Monticello Nuclear Generating Plant
Docket No. 50-263
Renewed Facility Operating License No. DPR-22

Prairie Island Nuclear Generating Plant, Units 1 and 2
Docket Nos. 50-282 and 50-306
Renewed Facility Operating License Nos. DPR-42 and DPR-60

Response to a Request for Additional Information RE: Xcel Energy Amendment Request to Create a Common Emergency Plan and Emergency Operations Facility for Monticello and Prairie Island (EPID: L-2021-LLA-0210)

**RESPONSE TO A REQUEST FOR ADDITIONAL INFORMATION RE: XCEL ENERGY
AMENDMENT REQUEST TO CREATE A COMMON EMERGENCY PLAN AND
EMERGENCY OPERATIONS FACILITY FOR MONTICELLO AND PRAIRIE ISLAND**

Figure B-1, TSC Organization

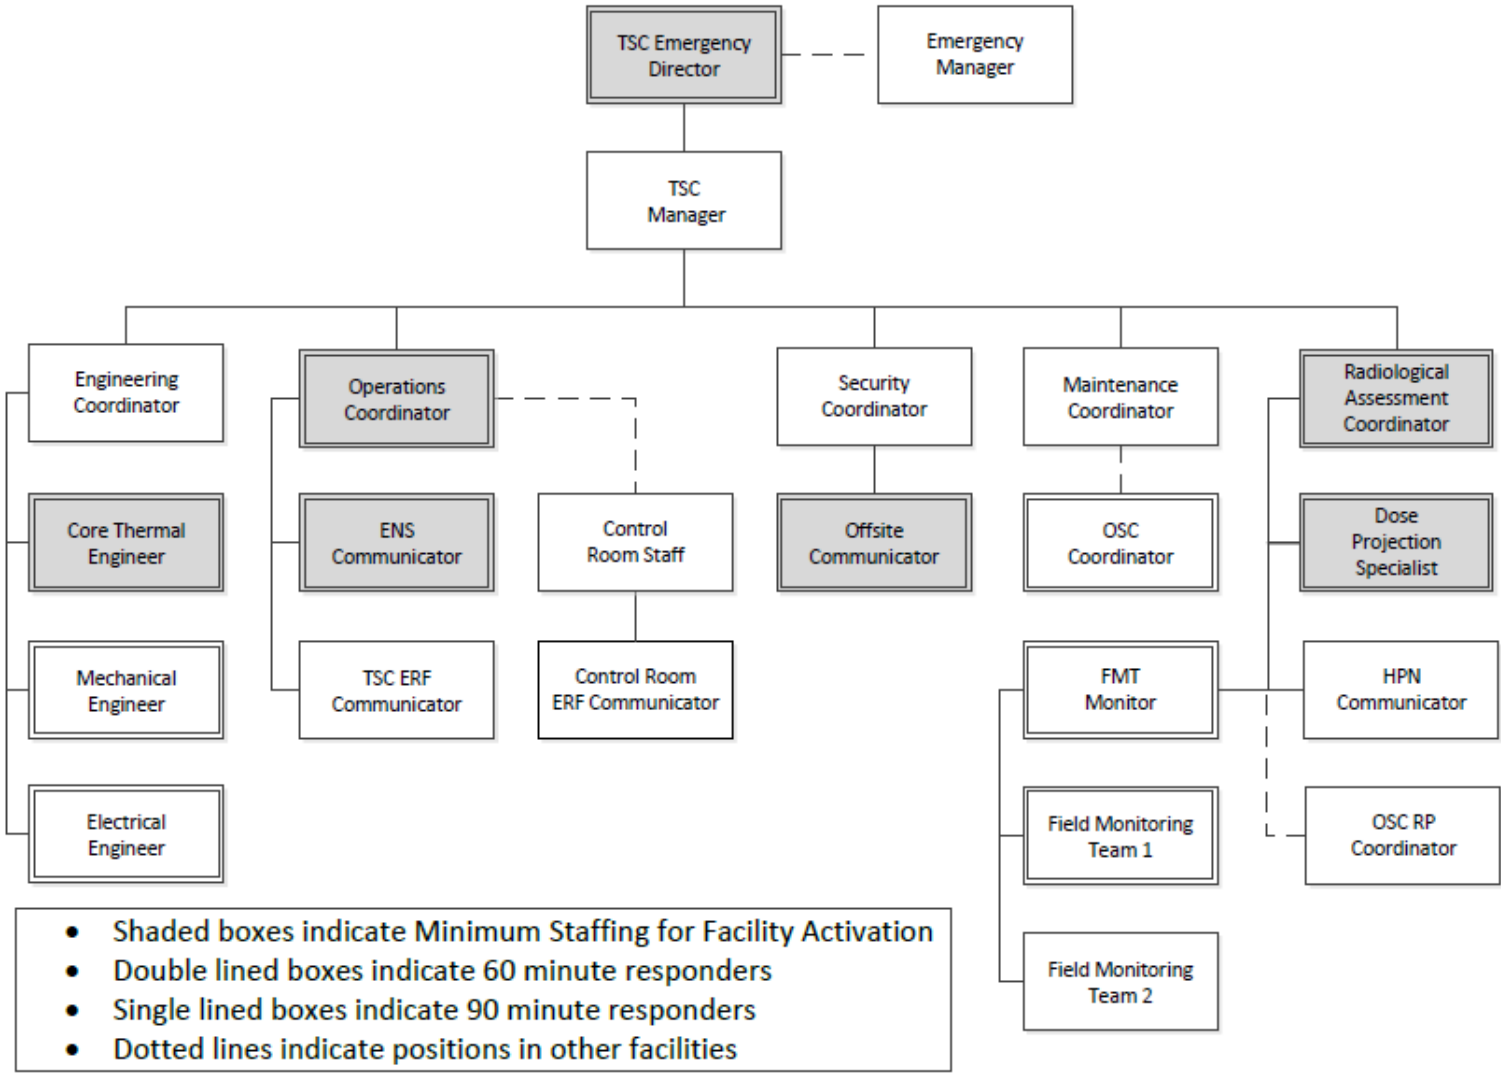
However, Figures B-1, “TSC Organization,” B-2, “OSC organization,” and B-3, “EOF Organization,” show minimum staffing for the respective facility activation that is not consistent with the Xcel Table B-1.

Request: Provide justification as to how these facilities can be considered staffed for activation with the level of staffing below the Xcel Table B-1 minimum staffing.

The proposed SEP provides for staffing of the required functions within 60 and 90 minutes of an Alert or higher classification to relieve and support the on-shift staff and effectively implement the Emergency Plan. The positions listed in SEP Table B-1 include the minimum on-shift and augmented staffing as identified in NUREG-0654, Revision 2, Table B-1 as well as the minimum staff for facility activation as identified in Figures B-1, B-2, and B-3.

SEP Figures B-1, “TSC Organization,” B-2, “OSC Organization,” and B-3, “EOF Organization,” are intended to show the required staffing and applicable response times for each position. The positions in each figure annotated as “minimum staffing” represent a subset of the facility

For the TSC, the TSC Emergency Director, Core Thermal Engineer, Radiological Assessment Coordinator, Dose Projection Specialist, Offsite Communicator, and ENS Communicator positions in the Technical Support Center (TSC) will relieve the control room staff of classification, core damage assessment, emergency exposure authorization and NRC notification, responsibilities. The change removes the ERF Communicator as a minimum staffing position for activation of the TSC as this position is not required for performance of a command-and-control function. Additionally, the proposed change provides a Dose Projection Specialist as a minimum staffing position to support performance of dose assessment and PAR development in that facility. A comparison of the current Emergency Plans’ and proposed SEP’s TSC minimum staffing for activation is provided in the following table.

Facility Activation Minimum Staff Change Comparison		
TSC Minimum Staffing (MNGP / PINGP)		
Current Plan (Figure 13.1 / Figure 1)	Proposed Plan (Figure B-1)	Change Summary
Emergency Director	Emergency Director	None
ERF Communicator	None	Removed from minimum staffing for activation since this position is not required for transfer or performance of any command-and-control functions.
Operations Group Leader	Operations Coordinator	Title change for purposes of fleet standardization.
Radiological Emergency Coordinator	Radiological Assessment Coordinator	Title change for purposes of fleet standardization.
Offsite Communicator	Offsite Communicator	None
ENS Communicator	ENS Communicator	None
Core Thermal Engineer	Core Thermal Engineer	None
None	Dose Projection Specialist	Added position to minimum staffing for activation in support of dose assessment and PAR development functions.
